Customs Convention on the International Transport of Goods under Cover of TIR Carnets (TIR Convention, 1975):

Revision of the Convention - Amendment proposals for the Convention: Vehicles with sliding sheets

Vehicles and containers with sliding sheets

Note by the secretariat

Sketch No. 10

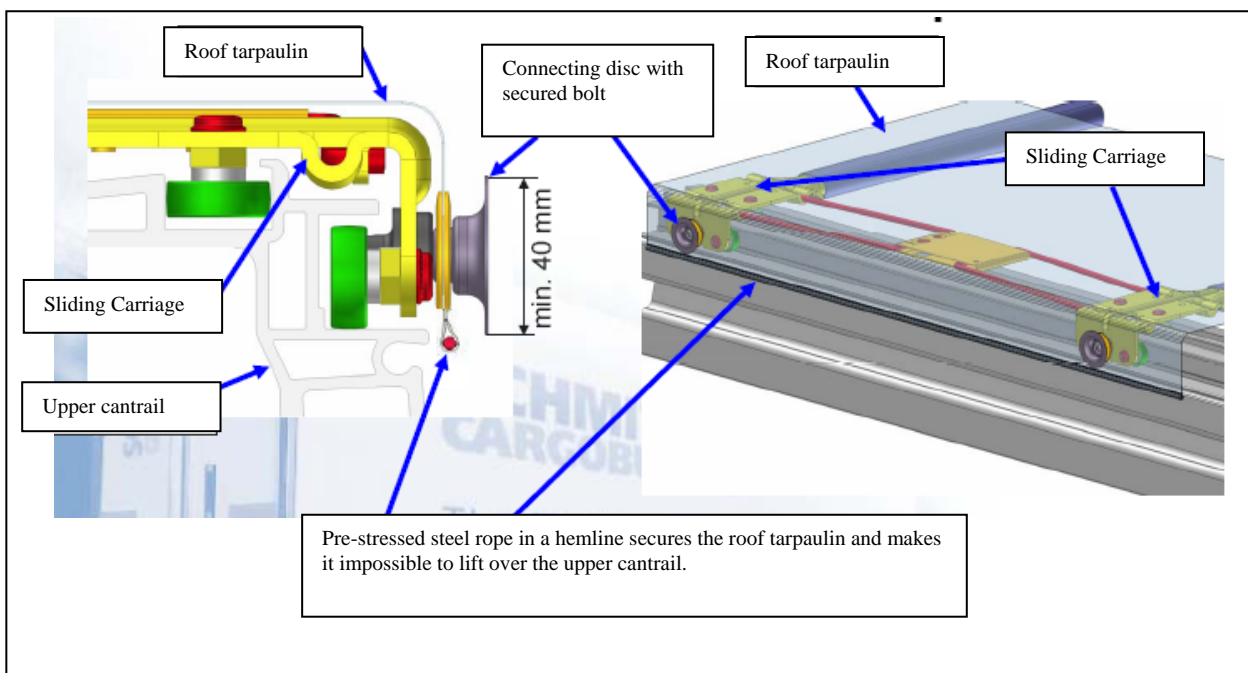
12. After Sketch No. 9 add a new Sketch No. 10:

This sketch shows an example of a container and of important points described within Annex 7, Part I, Article 6.
